**BCA ASSESSMENT REPORT**

**Oakdale South Estate, Horsley Park  
Precinct 2**

**Prepared For:  
Goodman Property Services Pty Ltd**

Revision 2

Figure 1 – Site 2A Perimeter Vehicular Access per BCA C2.4.

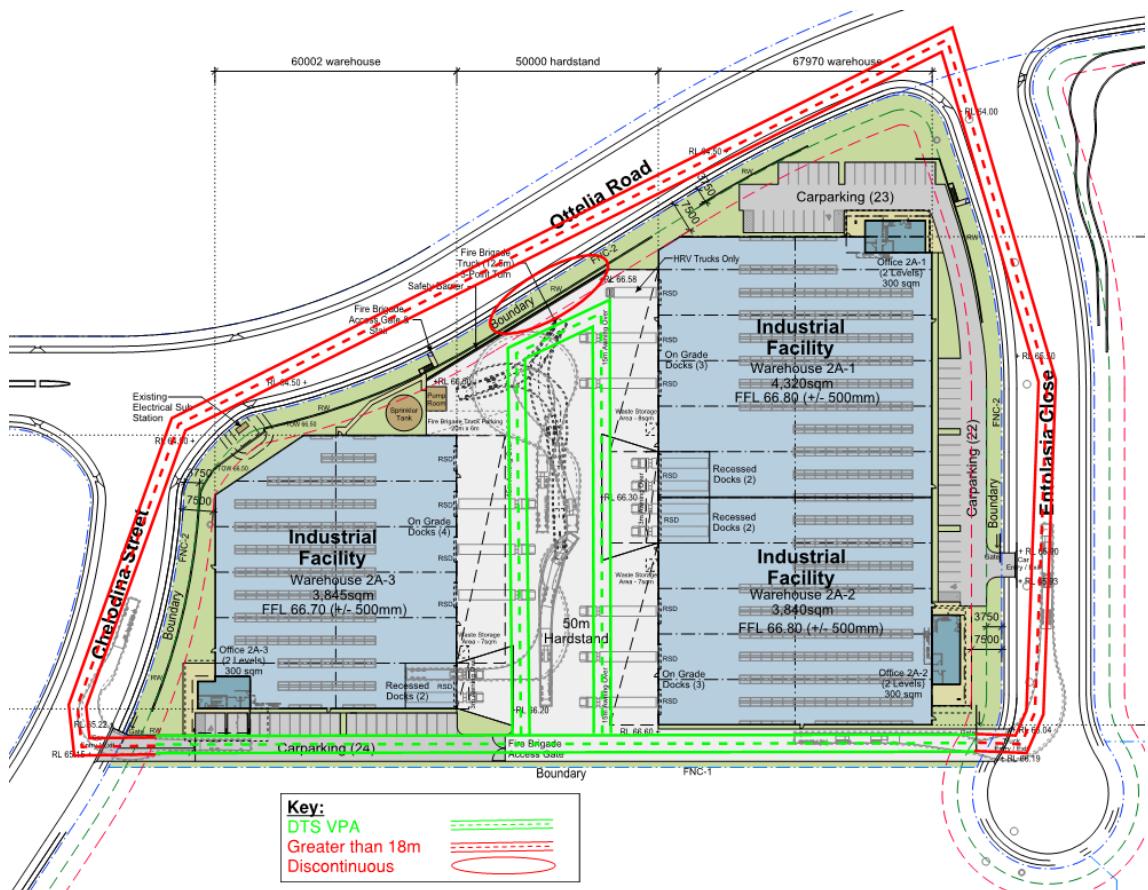
Comments: The proposed buildings do not comply with the provisions of C2.4 and thus the following non-compliance areas are identified on the site plan that are required to be addressed as an Performance Solution by the Fire Safety Engineer for each building:

- Site 2A: (i) The furthest part of the vehicular access path is greater than 18m from the external wall along Chelodina Street, Ottelia Road and Entolasia Close; (ii) Vehicular Access is discontinuous between Ottelia Road and the hardstand areas.
- Site 2B - The furthest part of the vehicular access path is greater than 18m from the external wall along Chelodina Street and Entolasia Close

**Note 1:** The driveways providing vehicular perimeter access must be designed with adequate loading capacities to withstand a fire truck and the gradients of the ramps should take into consideration to the FRNSW Policy 4 Vehicular Access Guideline.

**Note 2:** If the perimeter access paths are reduced to less than 6m in width to accommodate pedestrian egress paths per Clause D1.10 below, this will need to be documented in the Performance Solution.
